Project #3030684-LU

Correction Notice #1

Review Type : ZONING Date March 18, 2019

Project Address : 4311 7TH AVE NE SEATTLE, WA 98105

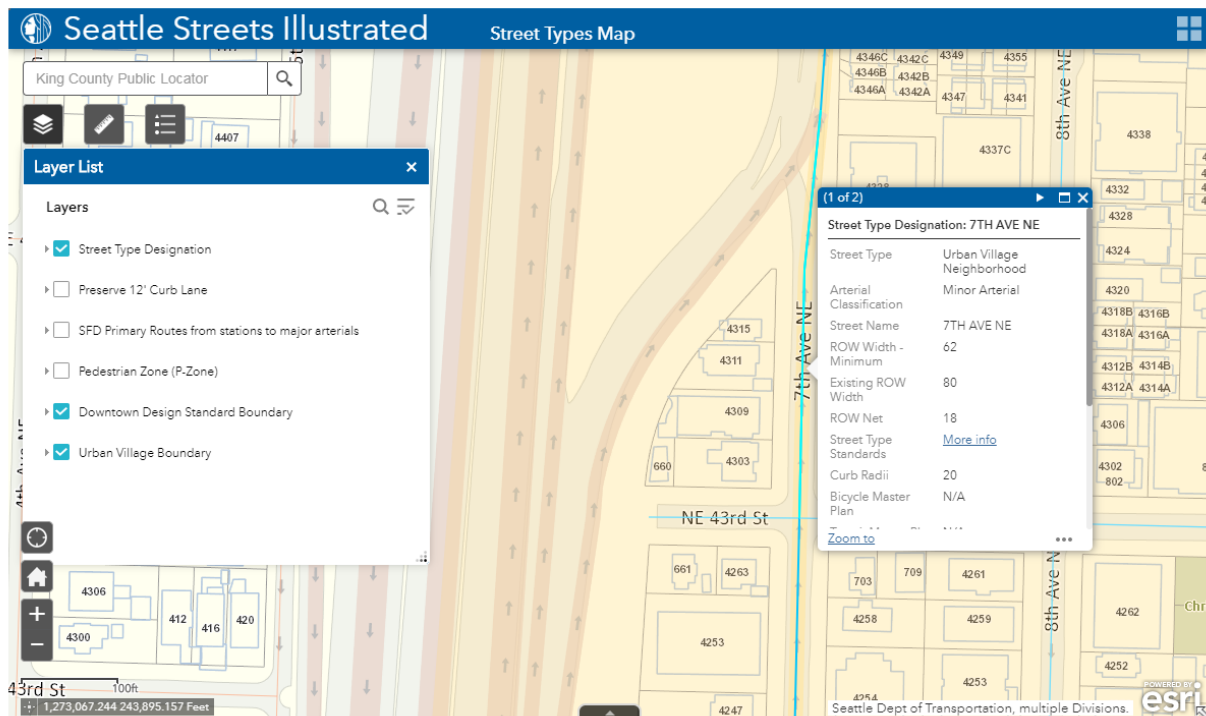
a) **the required 3' plus 3' setback** [([.015.D.1.b.1](#))]. Note: it appears that a large biplanter (structure) is proposed within the required 6' setback; while plantings to meet green factor may be approved in this location, structures are not allowed per [SMC 23.53.015.D.1.b.1](#))

It seems that "the required 3' plus 3' setback" highlighted above, has been incorrectly calculated. According to SMC [25.53.015. D.1.b](#) the correct figures are **1' plus 3' setback**

" Setback requirement. A setback equal to half the difference between the current right-of-way width and the minimum right-of-way width established in subsection [23.53.015.A.6](#) is required; provided, however, that if a setback has been provided under this provision, other lots on the block shall provide the same setback. In all residential zones except Highrise zones, an additional 3-foot setback is also required. The area of the setback may be used to meet any development standard, except that required parking may not be in the setback. Underground structures that would not prevent the future widening and improvement of the right-of-way may be permitted in the required setback by the Director after consulting with the Director of Transportation. Encroachments into this setback shall not be considered structural building overhangs, but the encroachment is limited to the standards set forth in Section [23.53.035](#)."

The preceding code has been quantified in the matrix below:

Current right-of-way width	60' (per Survey attached)
Minimum right-of-way width	62' (Seattle right-of-way improvements manual; snippet attached Exhibit 1)
A setback equal to half the difference between the current right-of-way width the minimum right-of-way width... an additional 3-foot setback is also required (Y)	$Y = \frac{1}{2} (\text{current ROW} - \text{min. ROW}) + \text{"additional 3-foot setback"}$ $Y = \frac{1}{2} (62' - 60') + 3'$ $Y = \frac{1}{2} (2') + 3'$ $Y = 1' + 3'$ $Y = 4'$ <p>In agreement with Rachel Huck (SDOT) see: Pre-submittal Conference Meeting Minutes Report (Exhibit 2)</p>

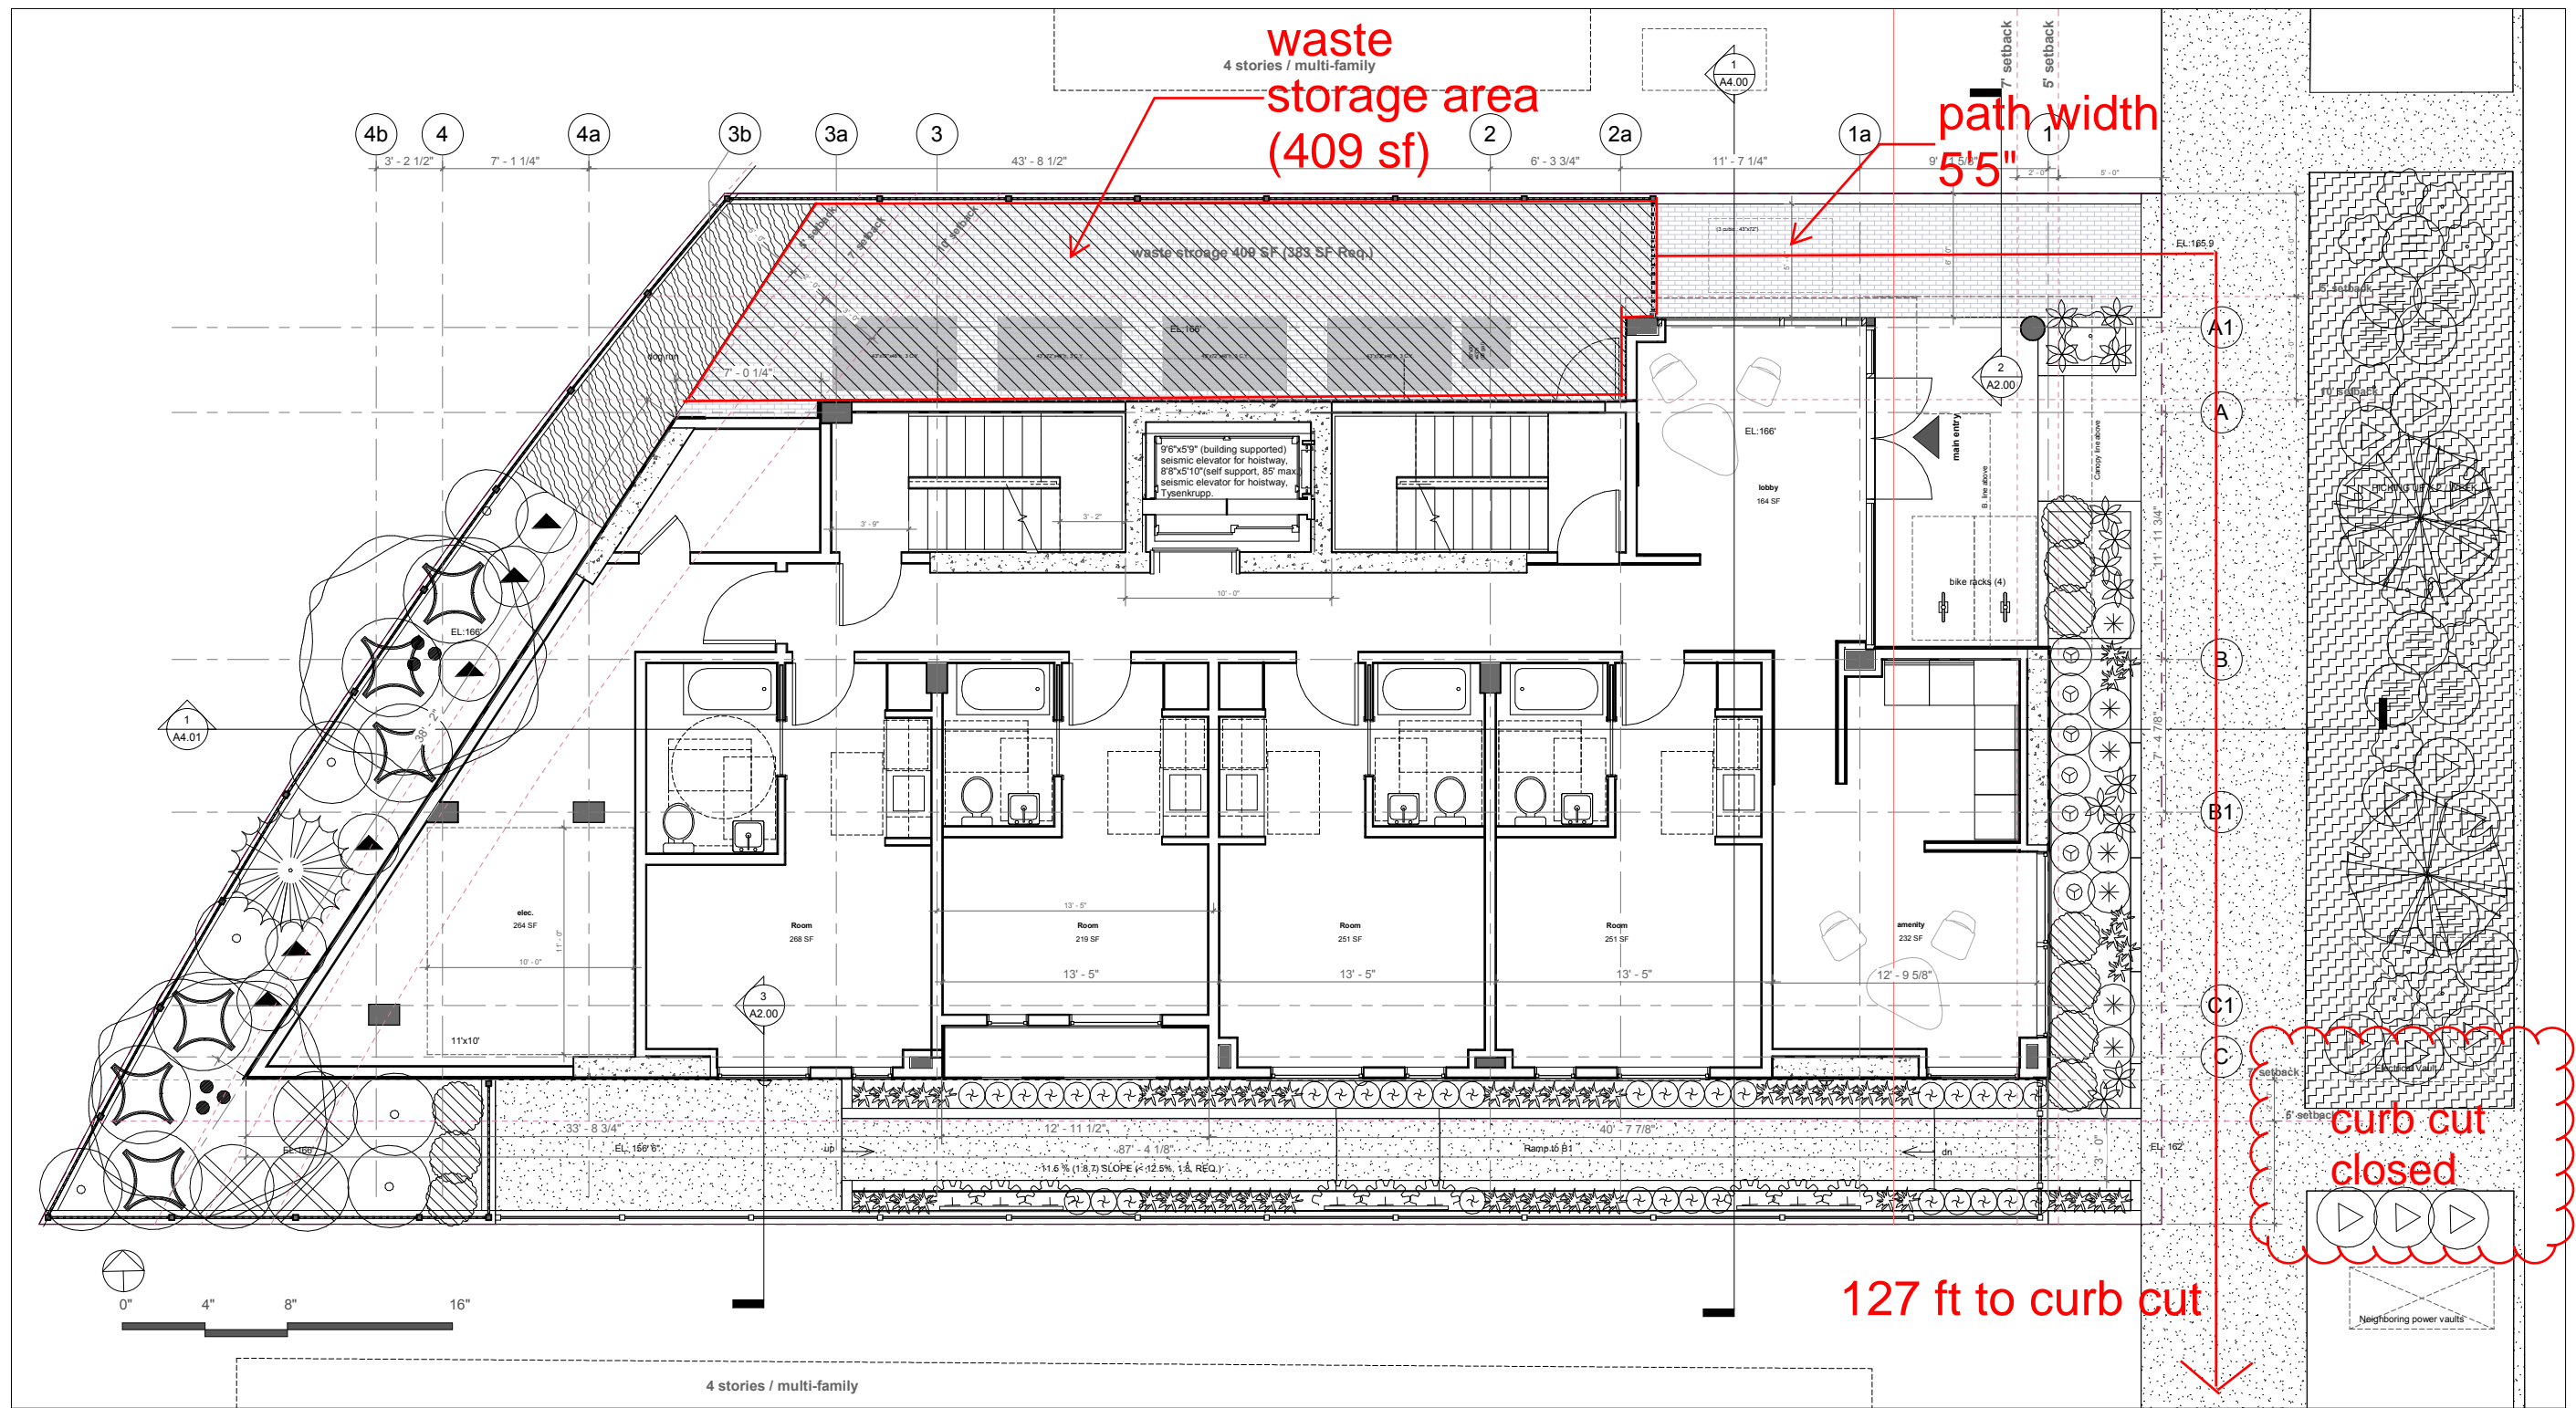
The solid waste enclosure will be code-compliant, with no fewer than **409ft²**. However, SPU recommends allowing a modification from code for the *minimum dimension of the storage area*, which is 9' 6" vs. a code-compliant dimension of 12'.

Please work with the assigned SDCI zoning reviewer to adopt this plan. **If the attached drawings differ from the MUP drawings, you will need to update your application to consistently reflect the attached proposal or contact me to work on a revised plan for solid waste storage and access.**
